**INDEPENDENT ADVISORY
PANEL FOR UNDERGROUND
MINING**

**MOOLARBEN COAL COMPLEX
UG4**

EXTRACTION PLAN

22 April 2022

Figure 3: Site S1MC280 position, relative to longwalls 402 and 403 (direction of longwall retreat is from right to left)

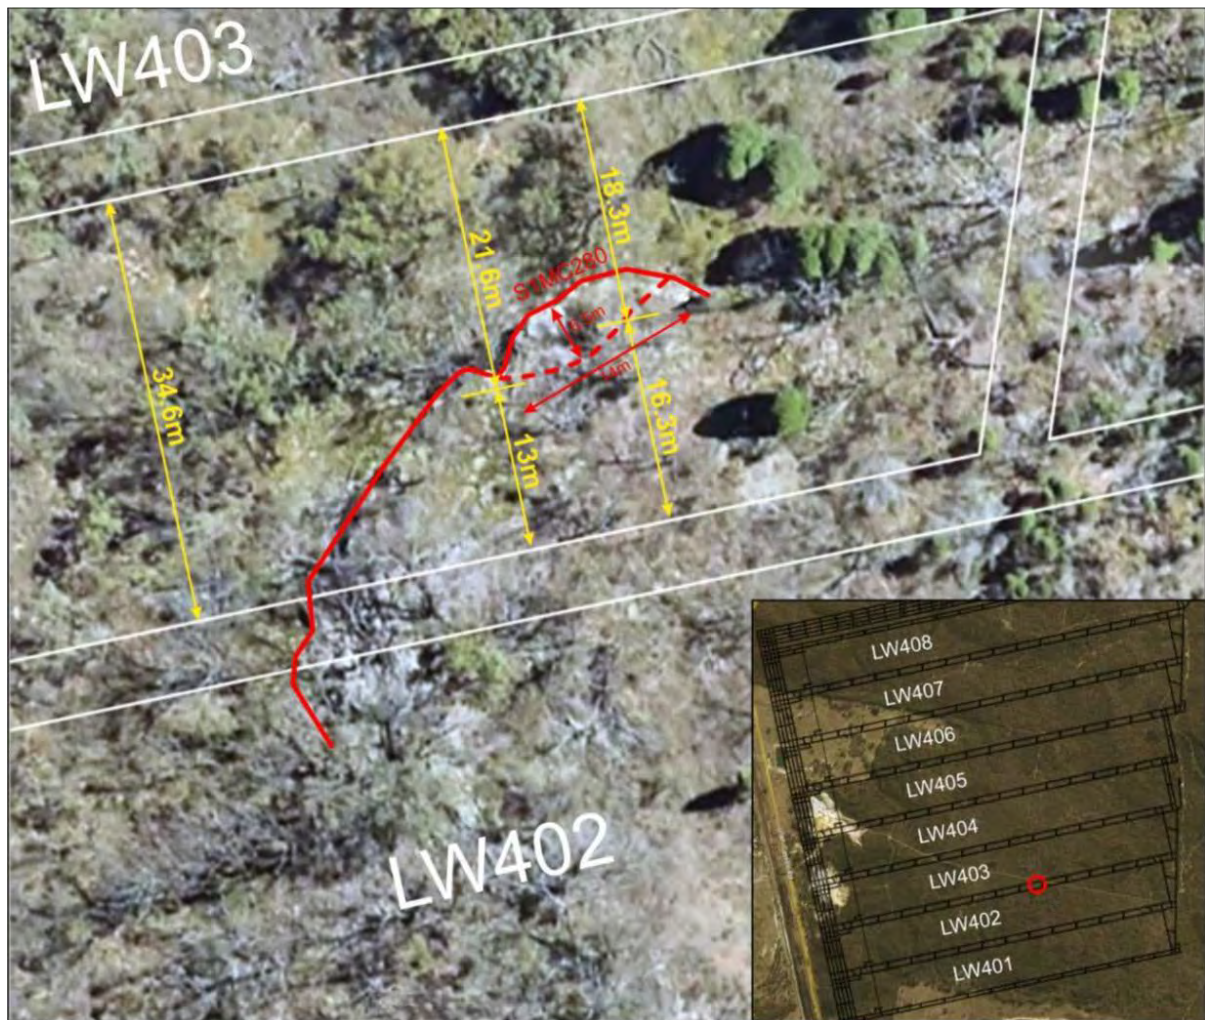
It is understood that the orientation of the shelter is such that LW402 will pass behind the shelter (up-hill), whilst LW403 will pass in front of the shelter. This configuration is indicated in Figure 3 below, taken from recent advice provided by the Applicant (22 March 2022).

The response to this request (22 March 2022) indicates a tilt of 5.0mm/m (presumably towards LW402, or into the hillside behind the rock shelter), as 402 passes. The resultant tilt after 403 then passes the site is then predicted to be 4mm/m (presumably in the opposite direction, or down-slope towards 403). The sense of these tilt values is yet to be confirmed by the Applicant/MSEC, but if this interpretation is correct, it would suggest an incremental rotation of the rock shelter of up to 9mm/m towards the down-slope direction, between the passing of 402, and when 403 has passed. Based on a plan provided by the Applicant (11.04.22), the maximum depth of the rock shelter overhang is approaching 6m+. This would result in a net incremental rotation of up to 54mm.

The Panel has serious concerns about the ability of the rock shelter overhang to withstand these levels of incremental tilt, especially when combined with some degree of potential cracking and/or shearing. The Panel therefore recommends that the Applicant should develop a mining plan, as part of the overall mitigation strategy for the site, to create a reduction in the panel

width of LW403 in the region where it passes Site S1MC280, to avoid any adverse tilt or strain impacts (beyond restoring the shelter to its original tilt configuration) as this panel passes in front of the shelter.

- a) The Applicant should identify and design a suitable “early warning” subsidence monitoring site above the 402/403 row of chain pillars, at least several pillars inbye of Site S1MC280, to monitor the subsidence effects and impacts of both LW402 and 403, ahead of reaching Site S1MC280, to determine the actual subsidence, tilt and strain figures, by comparison to the predicted values.

- b) Establish a comprehensive TARP for both the “early warning” site listed in (a) above, and for monitoring at the rock shelter.
- c) Provide a comprehensive mitigation plan for the site, to cover all actions to prevent any significant cracking or instability of the shelter due to subsidence, tilt or strain. This should include the planned stress-relief slotting design; consideration of temporary support of the overhang; and design of a LW403 Panel face shortening, to leave some additional coal in the vicinity of the site. This mitigation plan should also be linked to the above TARPs.

- d) Full details of this mitigation strategy and associated monitoring program and TARPs should be submitted to the Department for endorsement and approval, prior to the commencement of LW402.

Figure 4: Surface geology and known structures

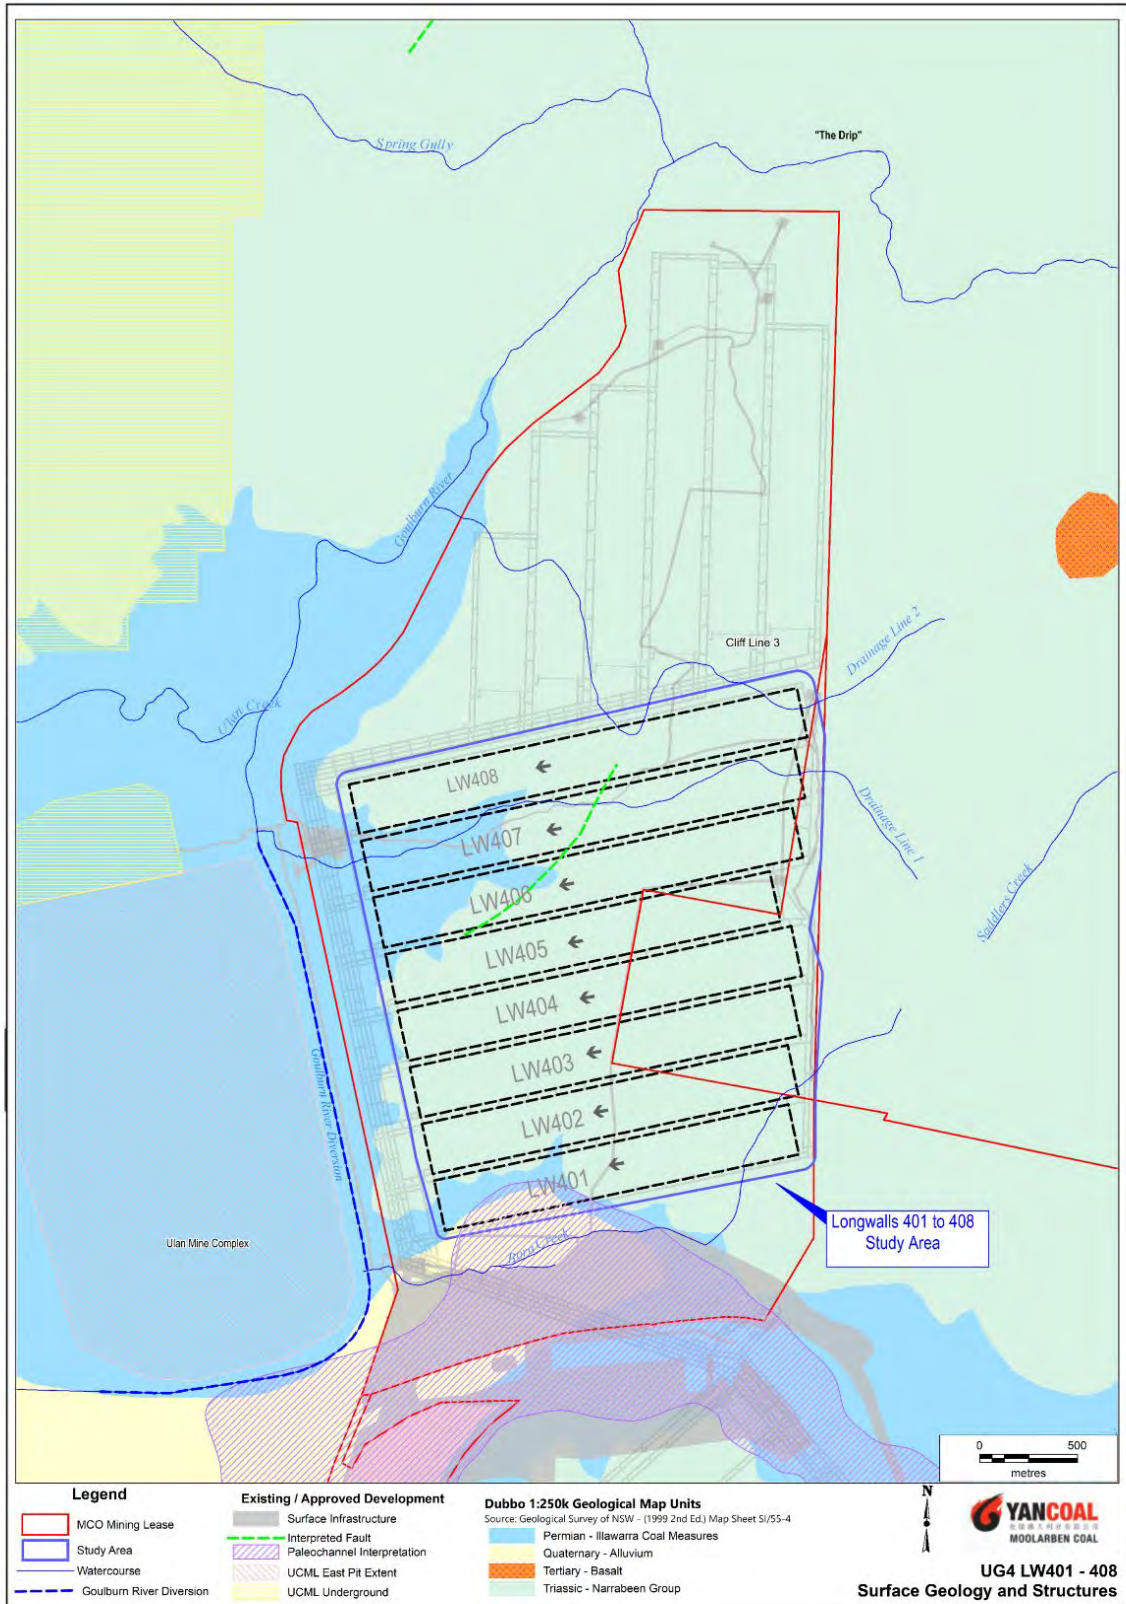
The surficial extent of these geologies is shown on Figure 4. While the mapped geology is well known there is minimal detail regarding structural features (such faults, fractures, and lineaments) across the UG4 area and adjacent areas. The only mapped and identified feature to date is an inferred fault extending from the south-western portion of LW406 through to the

central portion of LW408 and trending in a north-easterly direction (see Figure 4). Such features can enhance or restrict groundwater migration and flow.

- A geological structural analysis be completed as soon as practicable to determine whether there are any natural defects in the geology that could enhance or restrict groundwater migration and flow, and necessitate expanded monitoring and/or updated modelling

- An interim report on the geological structure and potential implications for groundwater impacts be supplied to the Department no later than 30 June 2022. Based on this report the Panel may provide further advice on additional groundwater monitoring or the siting of proposed monitoring bores (see Section 4.3.3)

Figure 5: Existing and proposed environmental monitoring locations (from Yancoal, 2022)

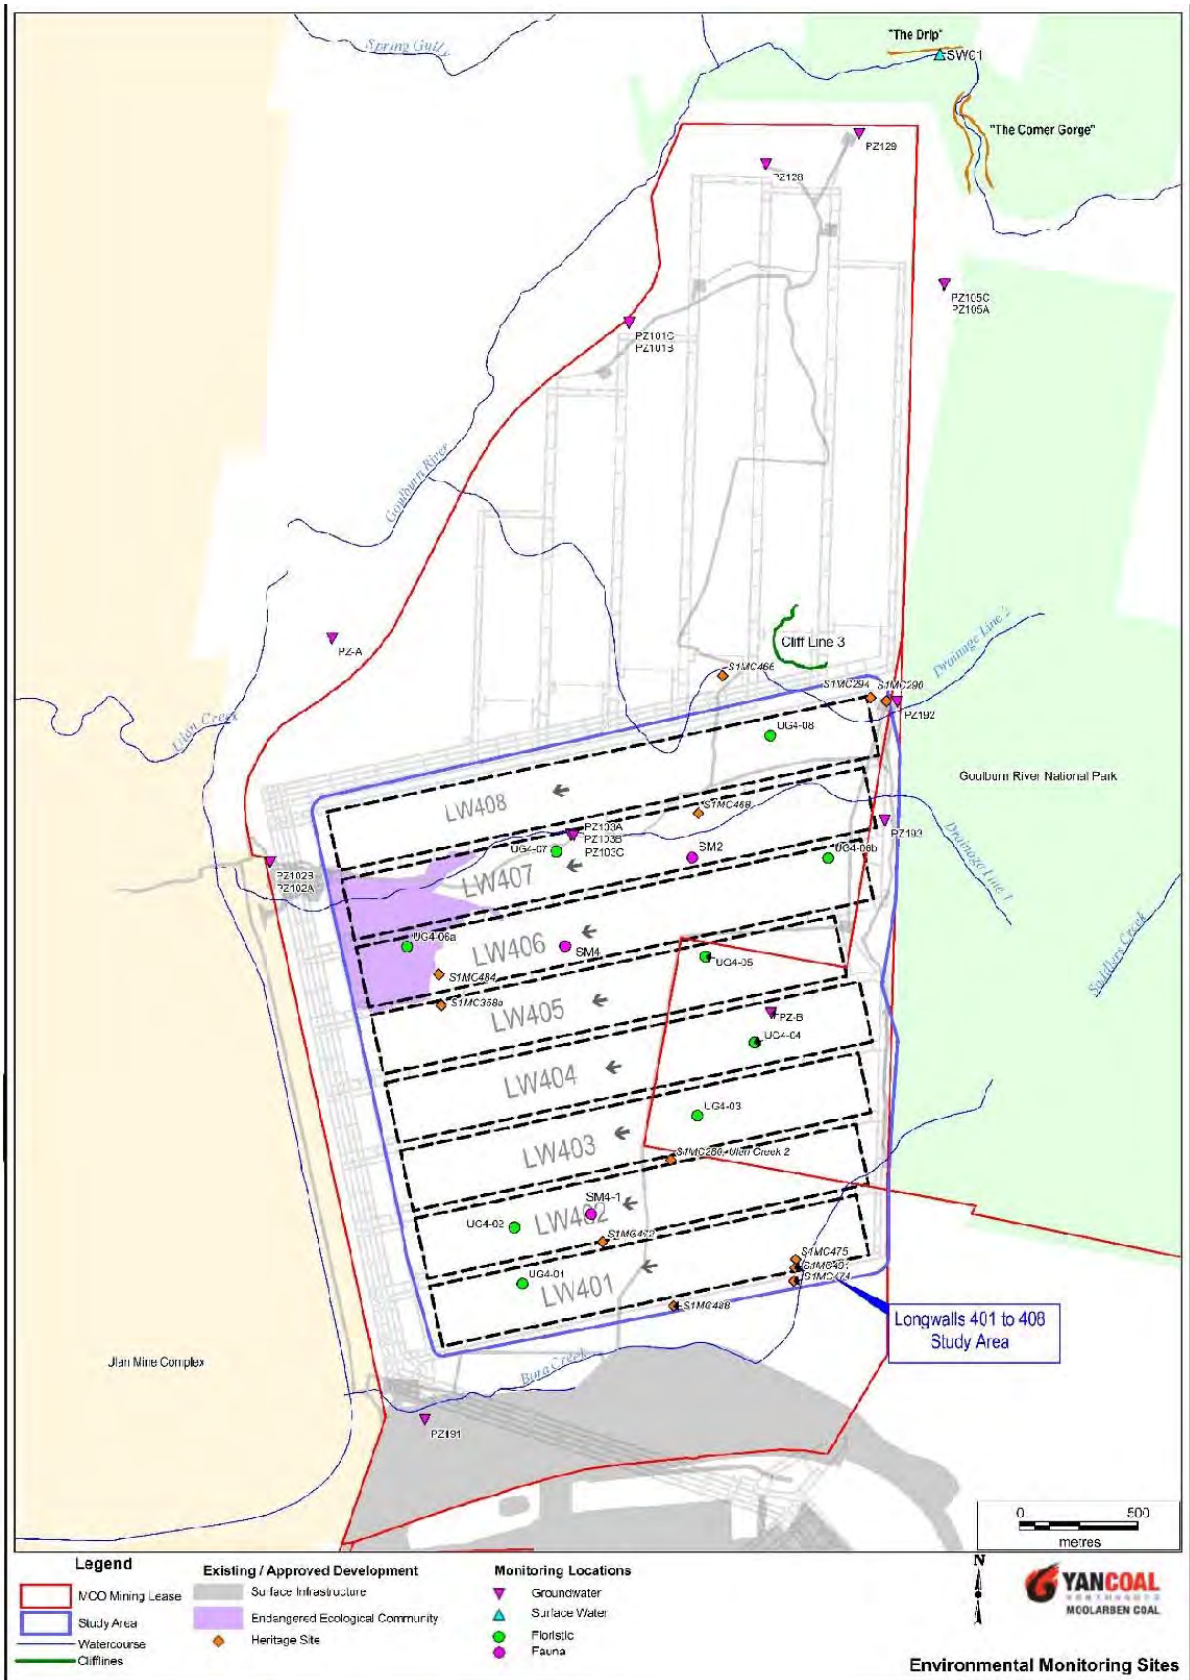
- Saturated thickness of the sandstone increases to the east from about 5m in the vicinity of PZ103C to approximately 20 to 30m in the vicinity of PZ192 and PZ193 (for locations see Figure 5).

A number of additional monitoring sites are proposed to be established as part of the UG4 Extraction Plan. These additional monitoring points are focused on measuring potential impacts on the Goulburn River downstream of UG4 LW401 to LW408 (i.e. the natural part of the Goulburn River downstream of the diversion, where some baseflow interaction is understood to occur). The following additional monitoring points are proposed (Figure 4.1) (Figure 5 in this Panel report):

The Panel supports additional groundwater monitoring locations and recommends extra nested sites in addition to those proposed in the Extraction Plan. The Panel's comments on the nominated sites are:

- The expanded monitoring network should be installed prior to the completion of LW401 (ie within the next 6 months) with the two monitoring sites located at the start of LW401 and LW403 completed prior to the commencement of LW401 (see Section 4.3.3)

13. Install additional groundwater monitoring bores at six sites (in addition to those nominated by the Applicant in the Extraction Plan):
 - i. Nested dual standpipes (two sites) (each monitoring lower Triassic sandstone and Permian ICM overburden) along the eastern boundary of UG4, ideally at the start of LW401 and LW403

Figure 6: Triassic sandstone saturated extent and groundwater contours (2011)

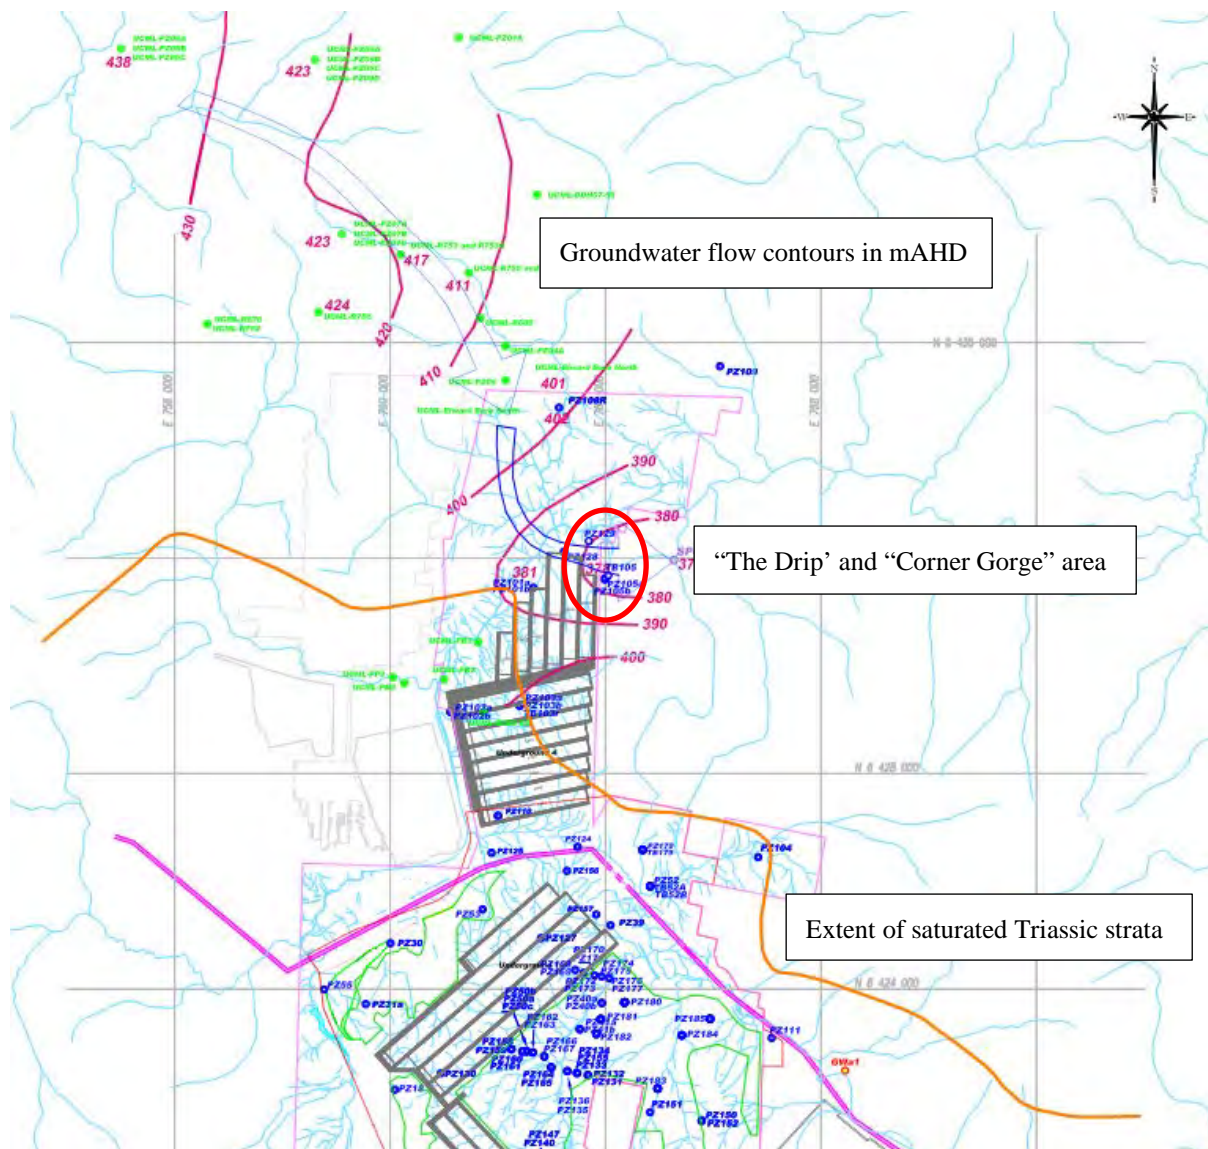
There is a lack of data in the vicinity of LW401 to 408 to properly define the saturated extent of Triassic sandstone and the current groundwater flow contours. Based on limited 2011 site data, Figure 6 (reproduced from RPS Aquaterra 2011) shows the extent of saturated Triassic strata and the groundwater level contours for the sandstone aquifer at that time.

Figure 8: Triassic sandstone aquifer water levels to January 2021

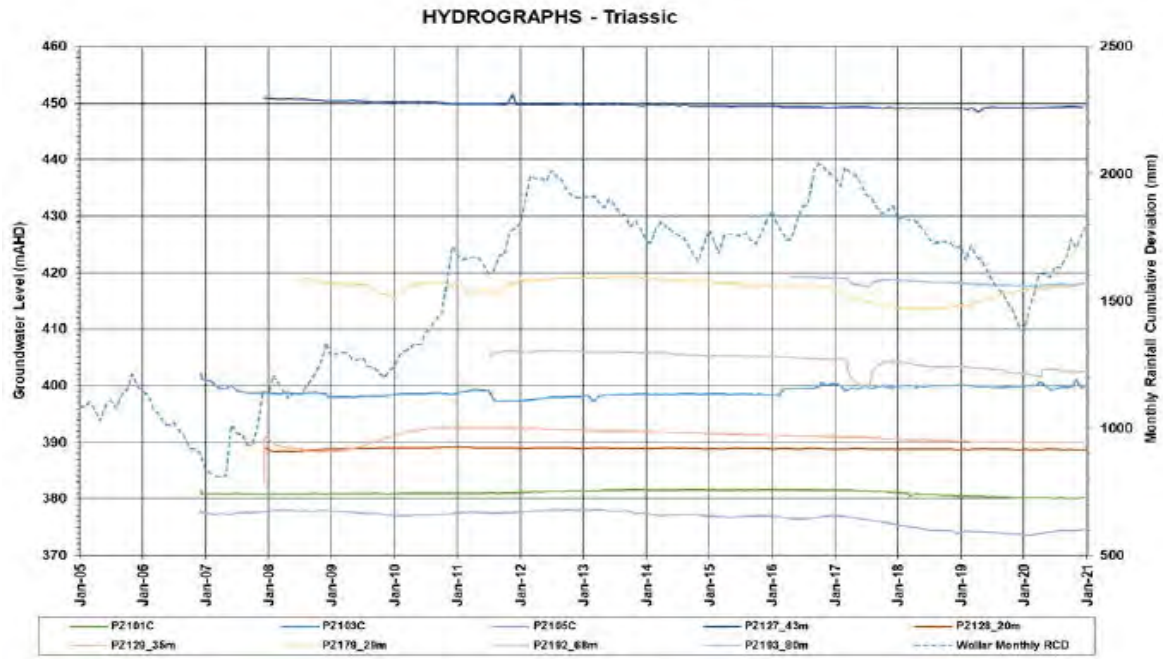
Based on the hydrographs presented in the 2020 AEMR (Yancoal 2021c) (see Figure 8), mostly seasonal variations in water levels are evident in the Triassic sandstone aquifers in the vicinity of LW401 to 408 and towards “The Drip”. The small declines in Triassic sandstone water levels at PZ192 and PZ193 in 2017 are the result of dewatering trials when 50ML of groundwater was pumped from MPB103.

Figure 9: Permian aquifer water levels at selected sites to January 2022

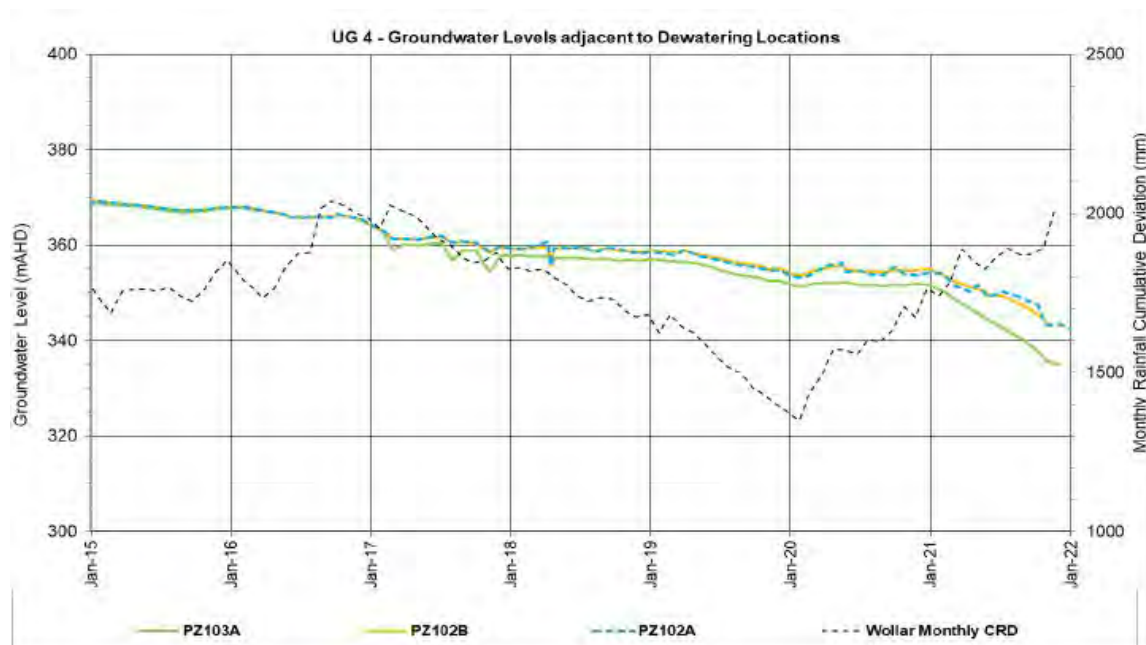
There is also insufficient site data to produce Permian overburden and Permian Ulan Seam water level contours for the UG4 area and to confirm flow directions and connectivity with the overlying Triassic sandstone aquifer. The recently supplied hydrograph (from Yancoal 2022) showing 15-20m declines in water levels in the deep Permian aquifers during 2021 at the PZ102 and PZ103 sites (Figure 9) is concerning. These two sites are located above and adjacent to LW407 and LW408 and emphasise the need for additional nested monitoring sites prior to the commencement of mining in the UG4 area. It is unclear whether these recent trends are Moolarben Coal Complex (MCC) or Ulan Coal Complex (UCC) related.

The Panel accepts that the coal measures are depressurised across the MCC due to historic and current mining activities resulting in regional water level declines in the ICM groundwater system. As a result of hydraulic connection and the height of fracturing above the proposed longwalls, groundwater will also drain vertically from the overlying Triassic sandstone aquifer (AGE 2021).
